SERVICE BULLETIN

Number 20141121

Title: Solution for water dripping from Evaporator region.

Models effected: XX ASR680, XX ASR1370, XX ASR2055

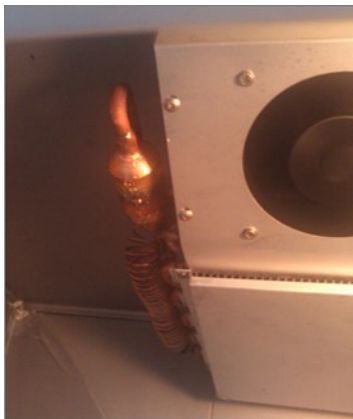
Reason: Earlier designs of the drip trays fitted did not cover the accumulator, suction line or return bends. Under high humidity and frequent door opening conditions, condensation forms on the accumulator and drips onto the Evaporator-Cover which is not part of the drainage system.

Accumulator Sitting forward of evaporator. Drip-tray only below finned area of evaporator.

1. Remove Evaporator-Cover and Drip-Tray.
2. Cover accumulator with Aeroflex. Securing with cable ties.
3. Use 2 x 8 gauge self tapping screws to attached the new Drip-Tray to the Evaporator-Cover.
4. Re-install Evaporator –Cover.

Accumulator covered with Aeroflex

New larger drip-tray screwed to Evaporator-Cover
